CERTIFICATE OF APPROPRIATENESS

Property: 3500 White Oak Drive, Tracts 11 & 12, Block 278, Houston Heights Subdivision. The property includes a historic one-story wood frame duplex and a historic filling station structure situated on an 8,800 square foot (88' x 100') corner lot.

Proposal: New Construction – Construct a new 3,920 square foot two story residence and attached two-story side garage. The house is proposed to face Cortlandt Street.

Recommendation: Deferral – project does not meet Criteria 1, 2, or 3 for New Construction.

NORTH ELEVATION

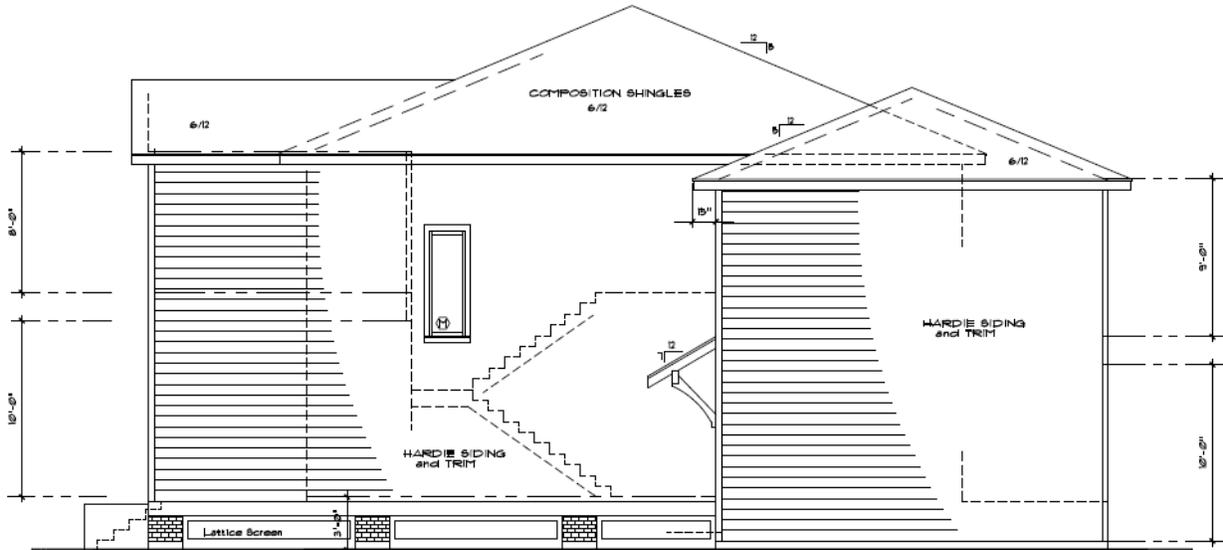
The proposed residence only contains a single window on the north elevation, and this window is fixed. This fenestration pattern is not compatible with the exterior features of other contributing structures found within this historic district. The north elevation should feature additional windows which would be more in keeping with the fenestration pattern of the other contributing structures.

2. Need for more north elevation windows. Mr. Martinez will add more windows to the north elevation. We won't have a drawing by Thursday, but the architect will work with staff to add appropriate windows.

LOT COMPARISON

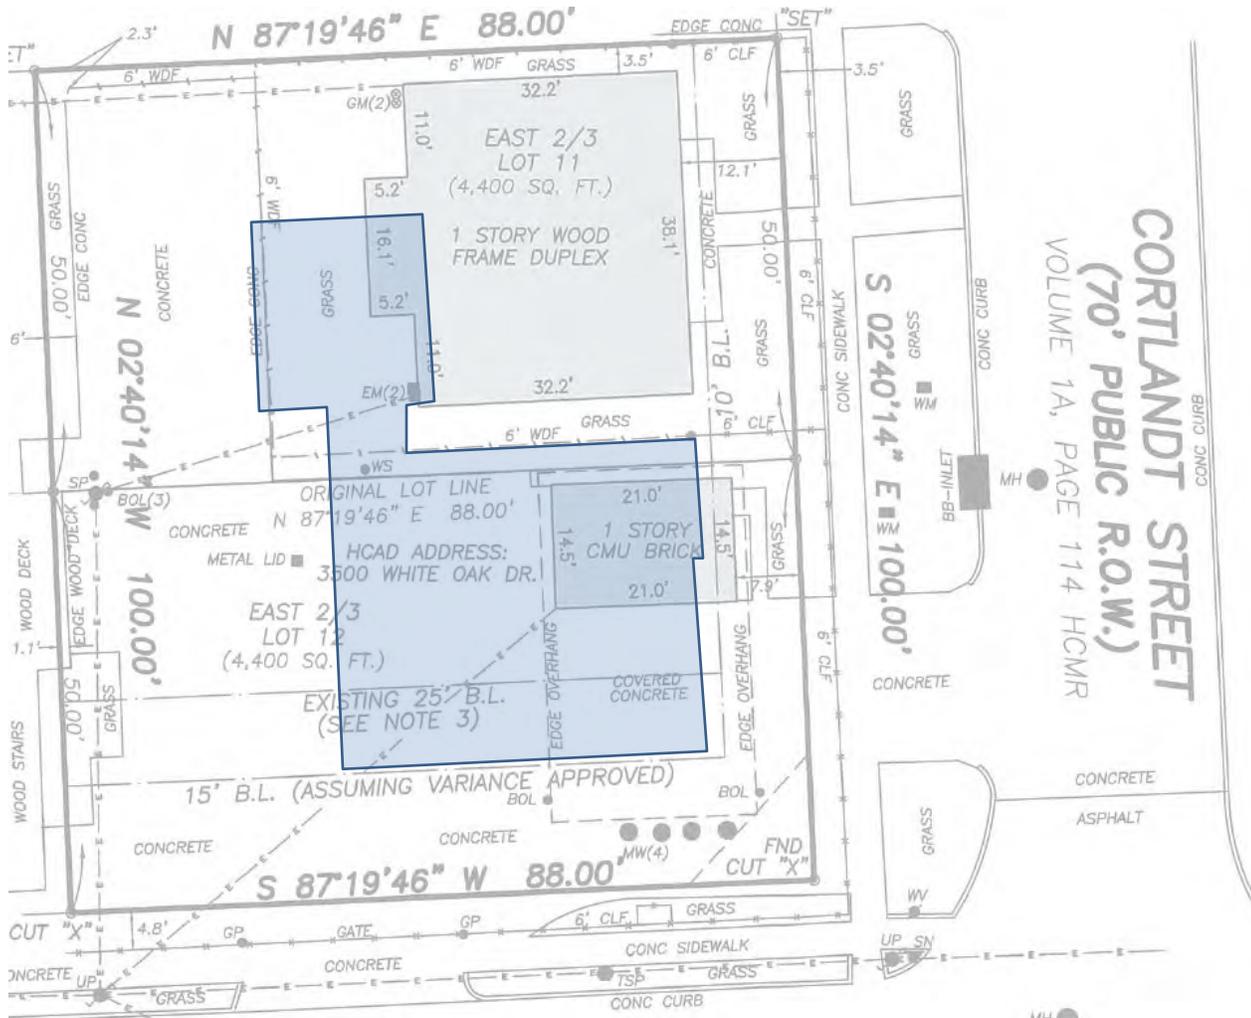
The proposed setbacks for the structure are 11'-8 1/2" on the front (facing Cortlandt Street) and 15' on the south side (facing White Oak Drive). Typical front setbacks in Houston Heights South are 20'. Despite the unusually large width of the lot, the applicant is requesting a setback variance for the south side of the house (along White Oak Drive).

White Oak Drive has a minimum building line of 25', so a variance is required for a 15' setback. Because the applicant's property is 100' wide, and the proposed house is only 39' wide, there is no justification for granting the applicant a variance to be closer to White Oak Street. Furthermore, the applicant's lot is 8800 square feet, which is larger than the typical lot size of 6600, so there is no hardship related to lot size that would justify a setback variance.

The typical development pattern in the Heights is to have detached garages located at the rear of the lot. The applicant is proposing a suburban-style lot placement with a side attached garage, which is not appropriate in this historic district. The typical setback for Heights garages is 100'. The applicant is proposing a garage setback of only 44', which is not appropriate. Although a 100' setback is not possible due to the depth of the property, the garage can be placed at the rear of the lot allowing for a 63' front setback (and 3' rear setback).

In Houston Heights, garages are detached and located at the rear of the lot, often fully or partially obscured visually by the house in front. As proposed, the attached garage is located at the side of the house, is only 44' from the front property line, and is highly visible.

To satisfy Criterion 3, the garage should be located as far to the rear of the lot as possible and should be tucked behind the house with the appearance of being detached. The proposed garage is 22' deep and the lot itself is 88' deep. If the house is to face Cortlandt St, the front of the garage should therefore be located at least 63' from the front property line, which allows for a 3' rear setback.

1. Side and front setbacks. I spoke with Mr. Martinez, he will move the house 10 feet so that there will be no need to get a side setback variance. This move addresses staff's side setback concern. He will also move the house toward the rear of the property so the front setback will be 24.6 feet rather than 11 feet. This move addresses staff's front setback concern.

4. Garage setback. As stated in No. 1, Mr. Martinez will move the house over and back. The garage will then be setback 57.5 feet. Staff asked for a 63 foot setback, but because we are moving the entire house, that would make the backyard only 3 feet. We moved it 13.5 feet back from what was originally proposed. The garage will remain attached.
